ADDENDUM NO. 2

Issue Date: April 29, 2021

Project Name: South Oslo Road WTP Improvements

Bid Number: 2021026

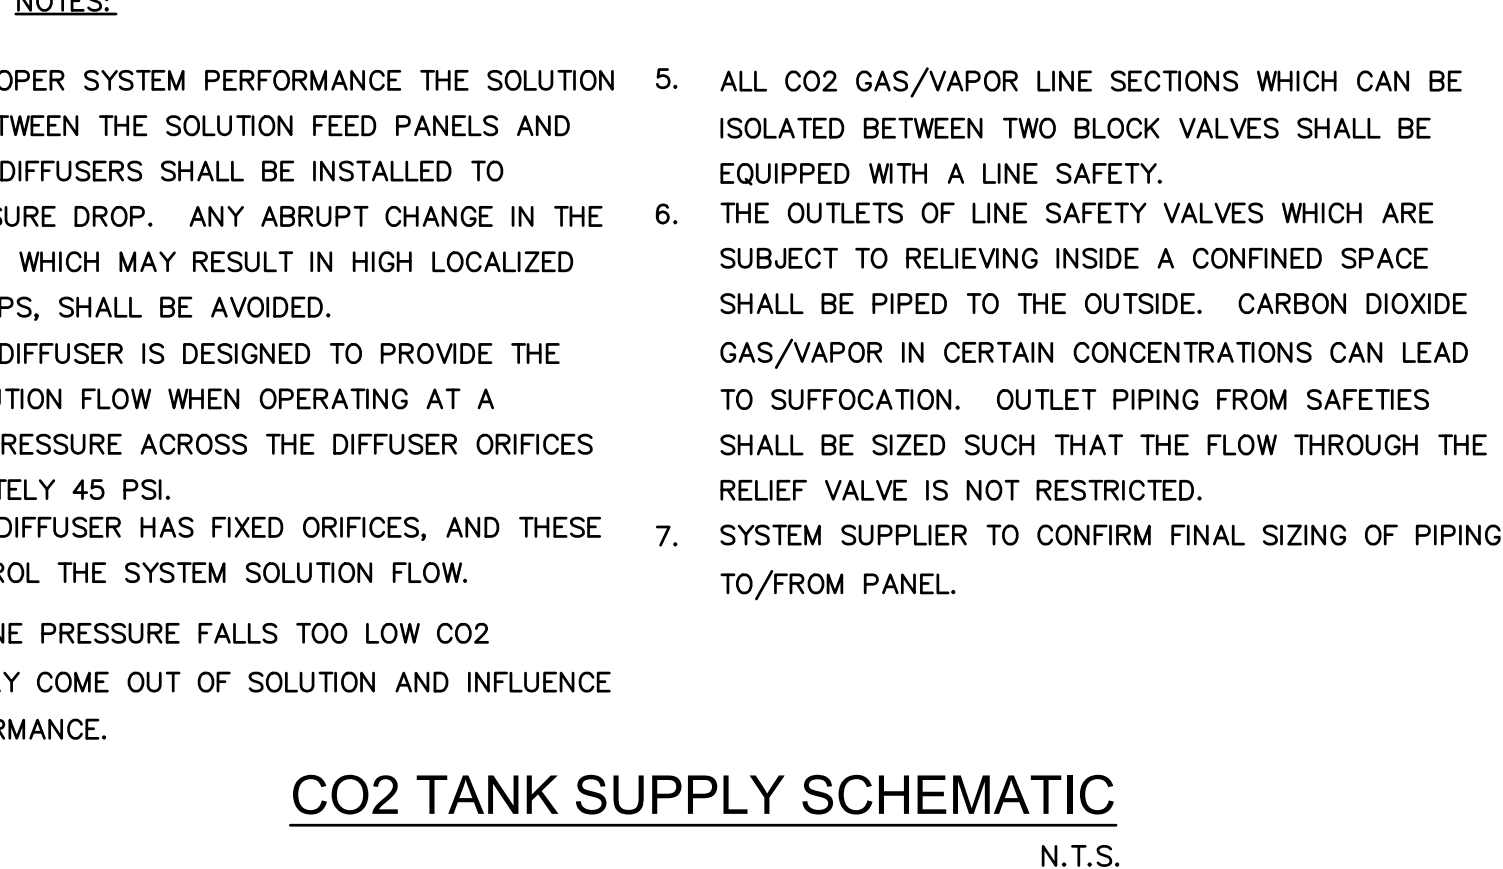
Question #9: The existing conduits in the RO building is Aluminum. Plans call for SCH. 80 PVC. Just checking.

Response: The design calls for PVC conduits in the process area. Aluminum in the airconditioned rooms, like control room areas, and electric room. A revised plan **sheet E-1** with the material schedule is included in this addendum response.

C-16

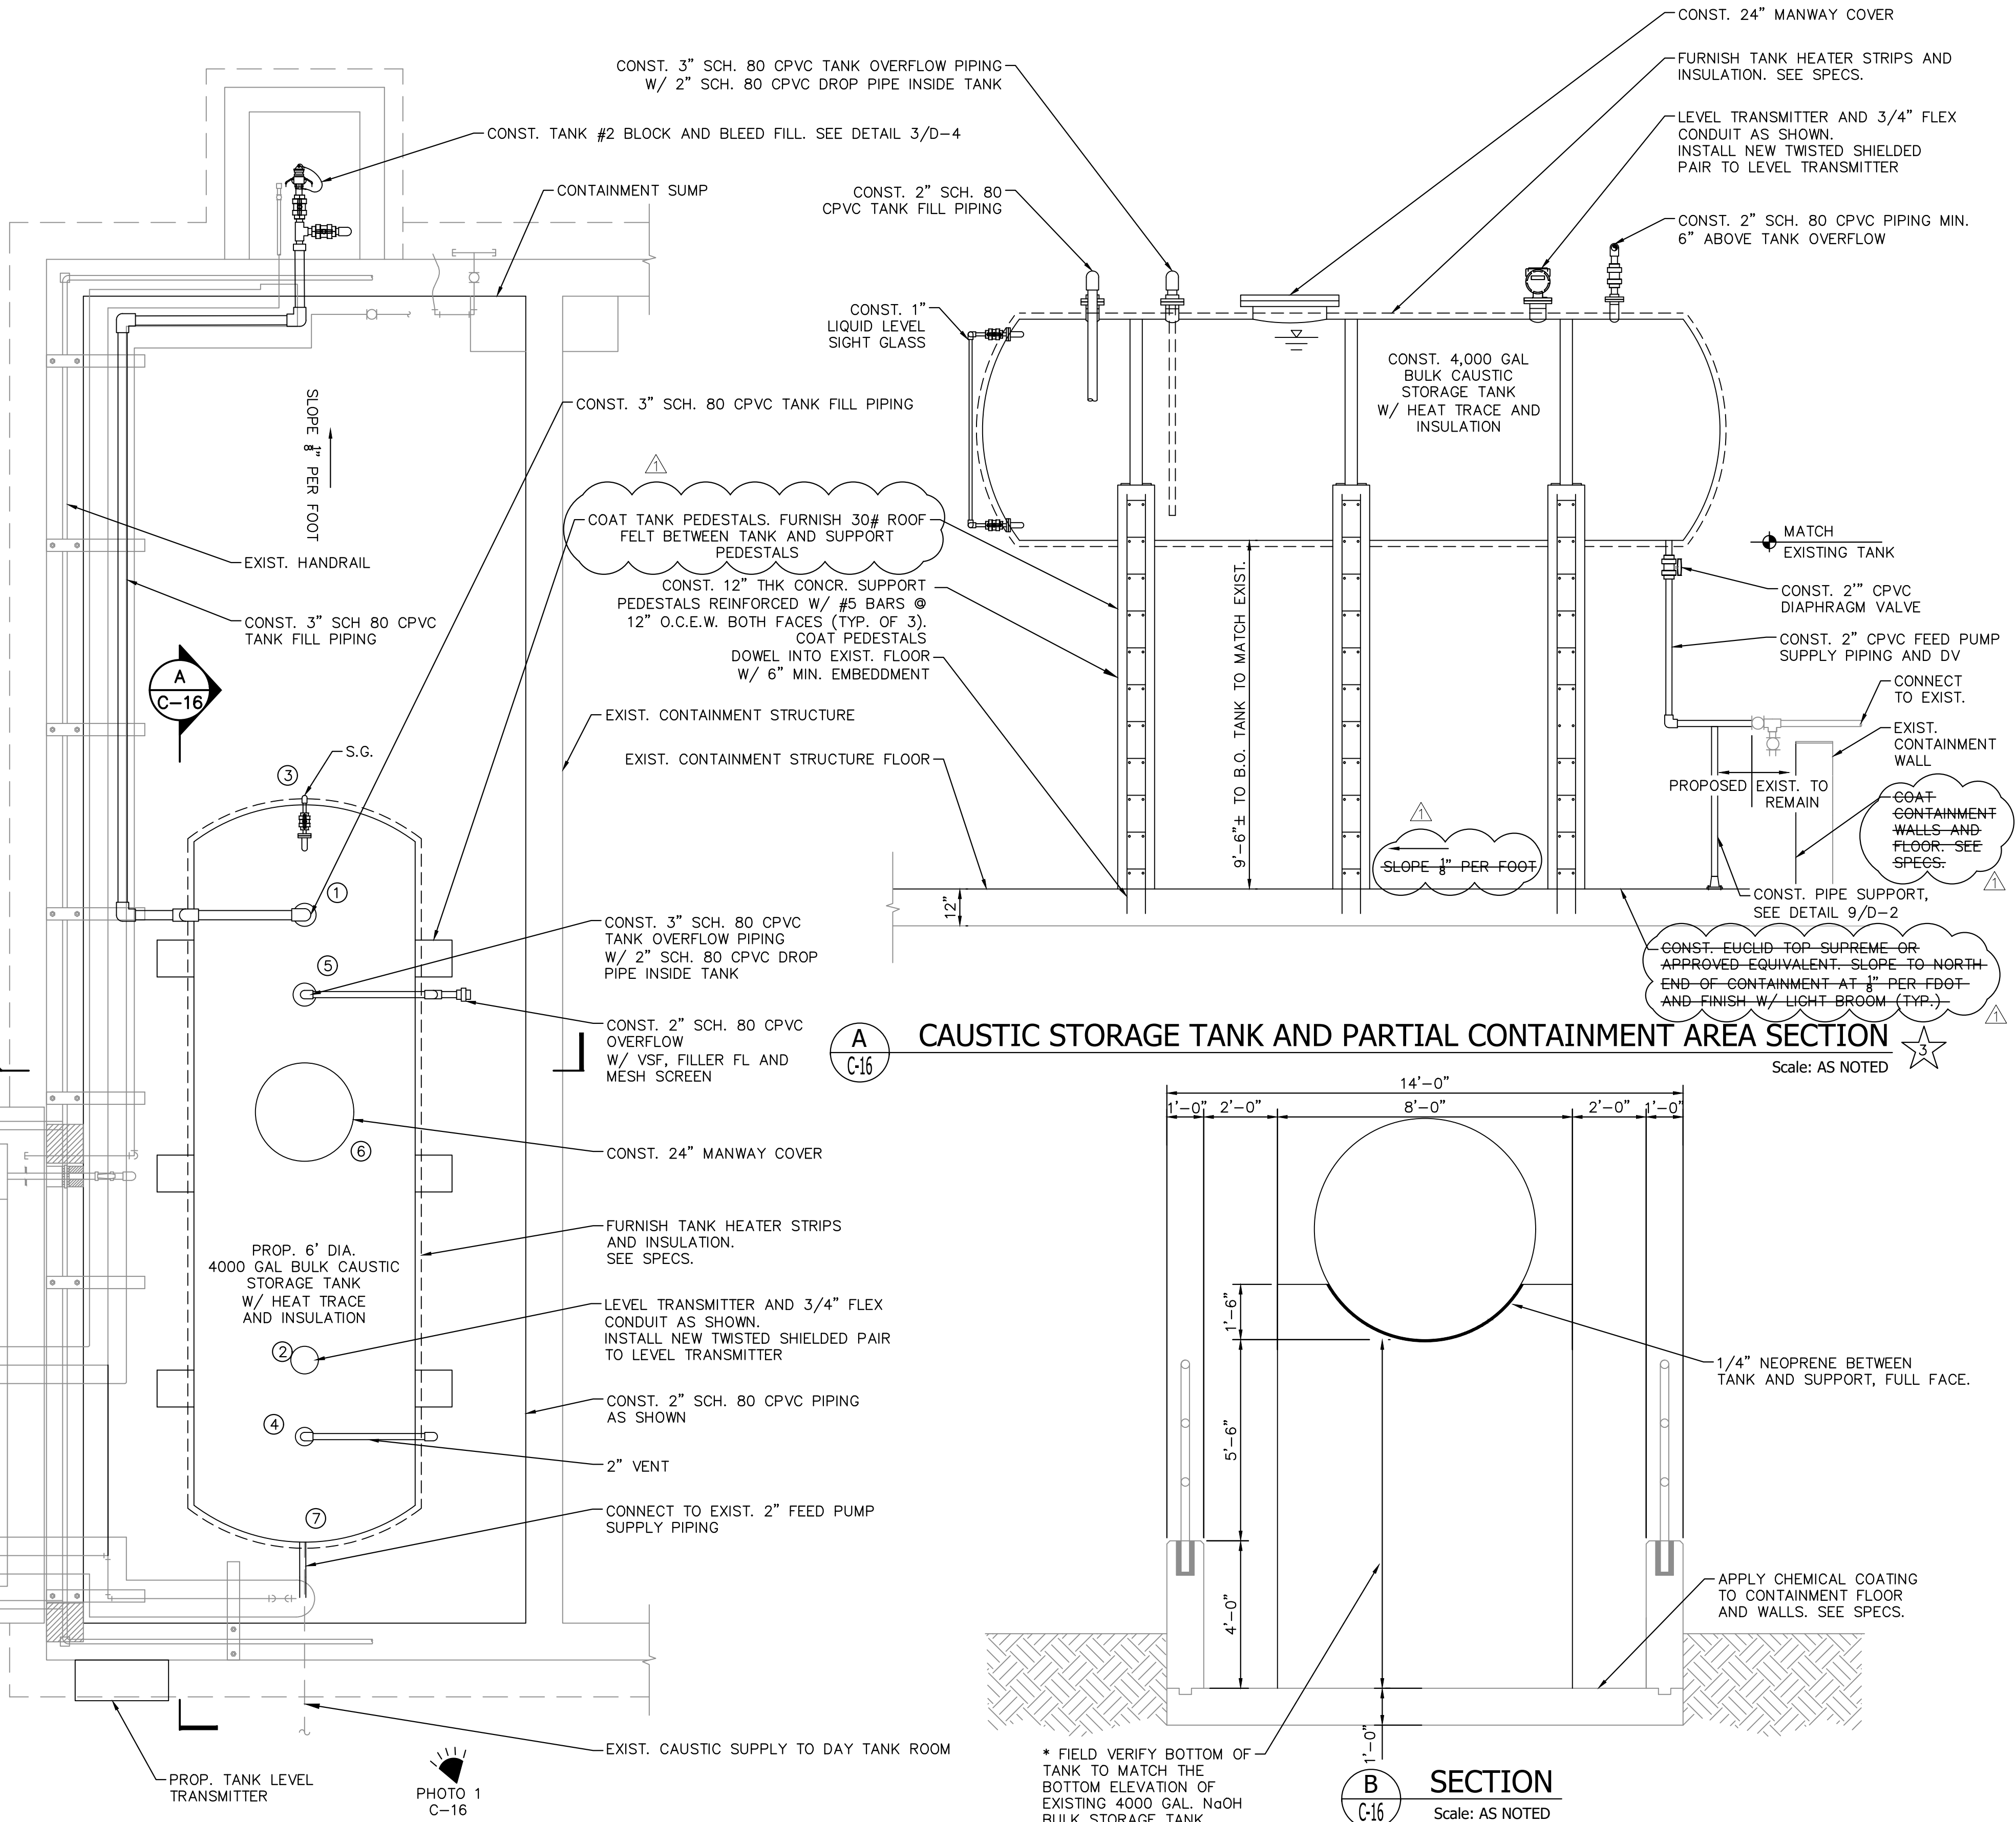
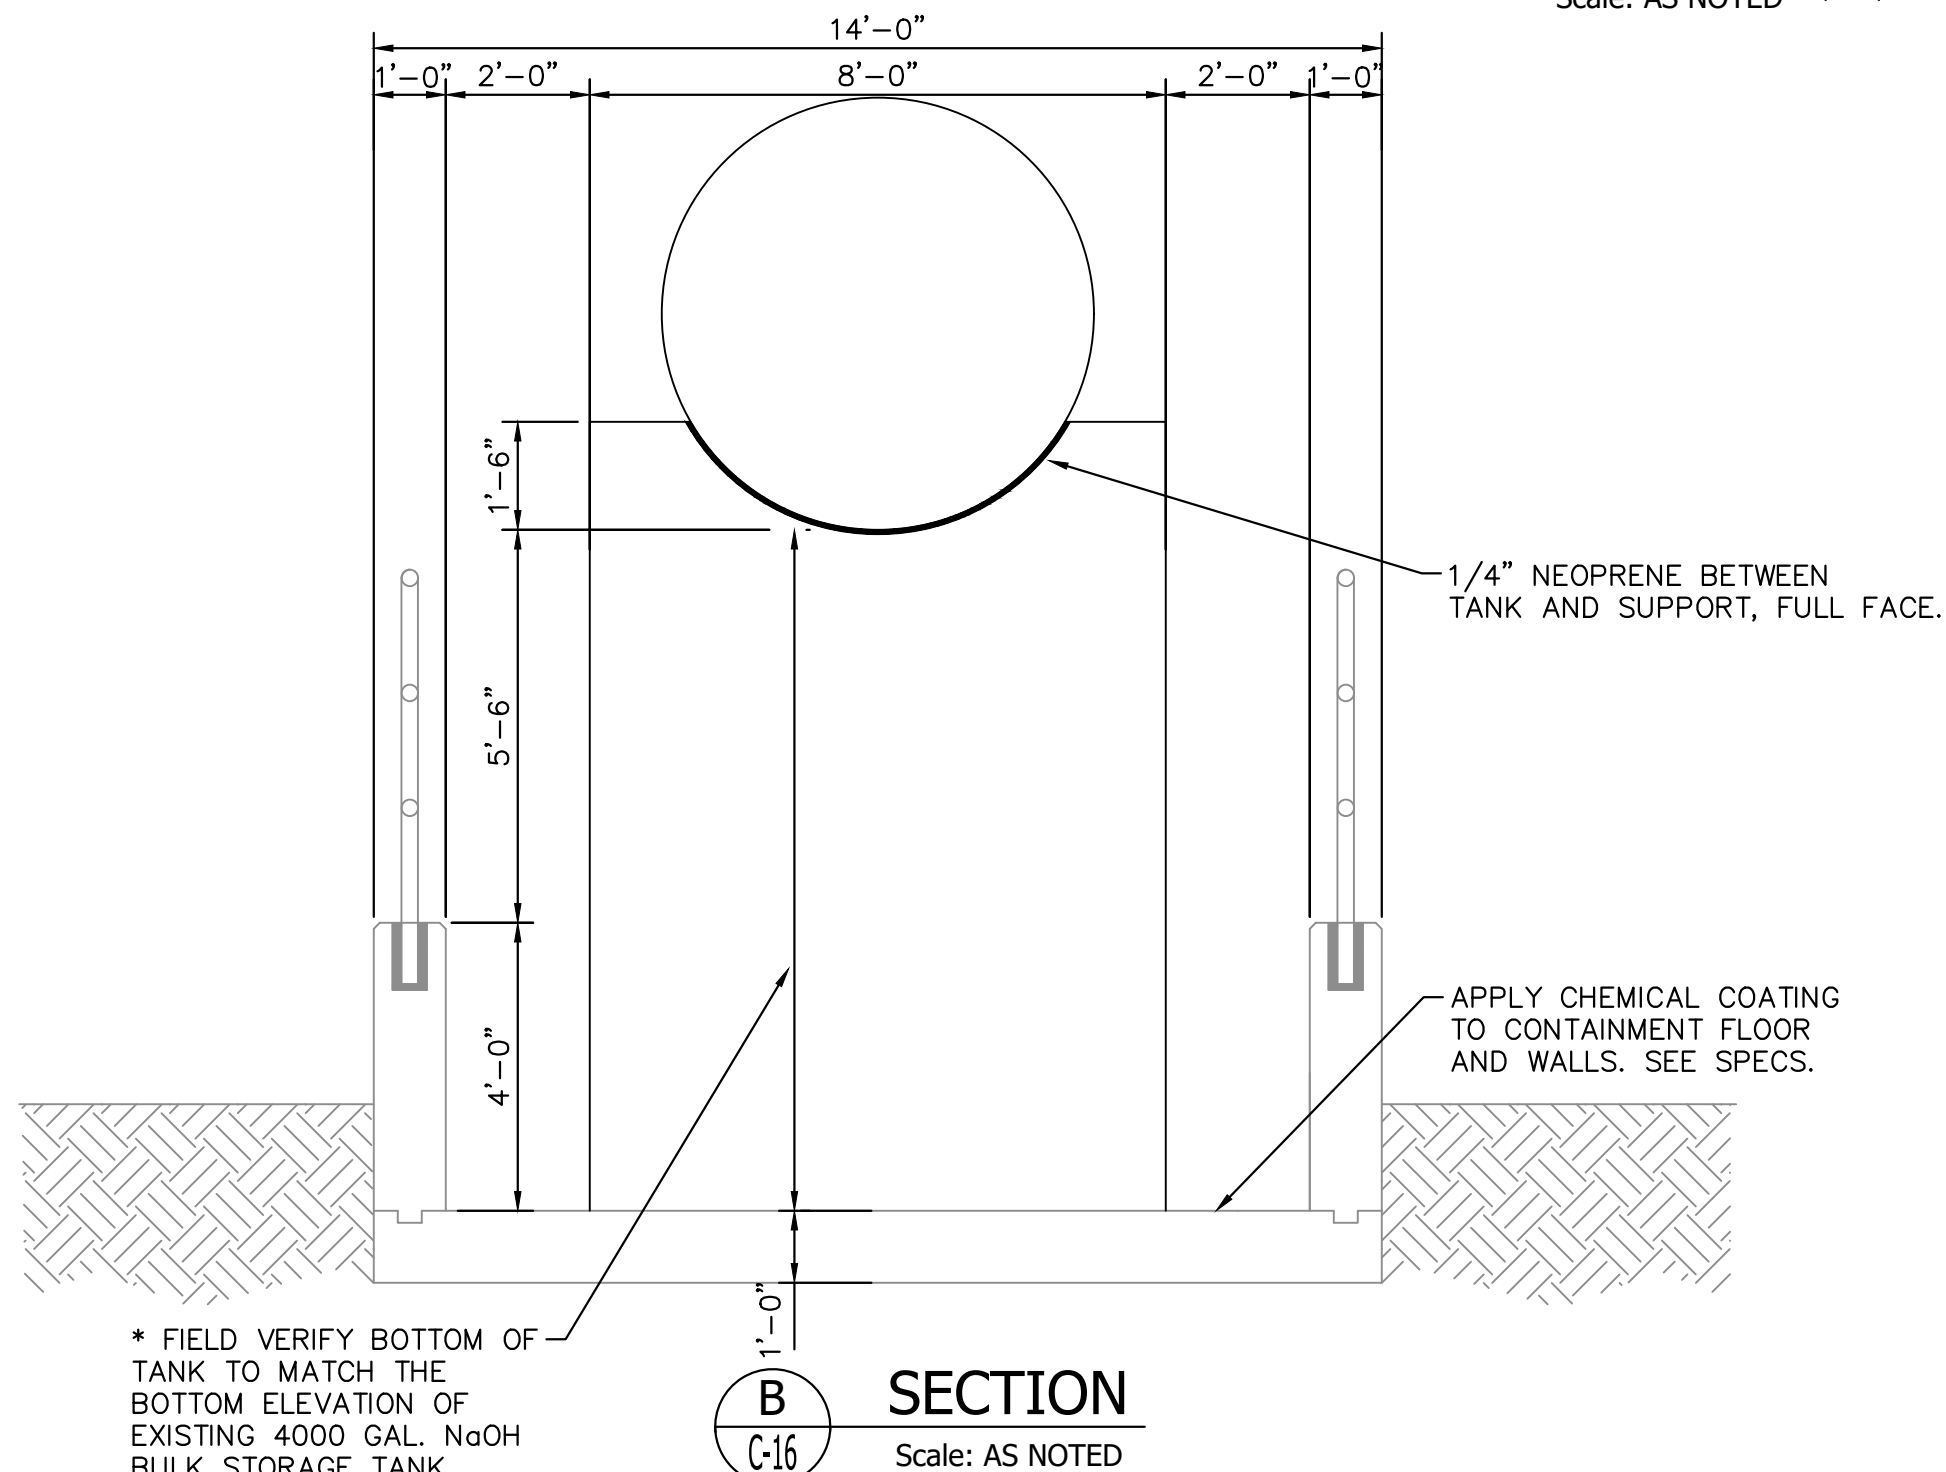
Question #4: Bulk Caustic containment area drawings states that floor, walls and supports have to be coated with a secondary containment system but there is no system included in the Specifications for this application. Please determine which (CRC-1, CRC-2 or CRC-3) and desired thickness.

Response: **Sheet C-16** has been revised to call for coating of the new tank pedestal supports, only. The floor topping and coating system for floors and walls has been removed from the scope of work. Utilize coating system described under 09900-2.5 B.3 for tank pedestal supports.
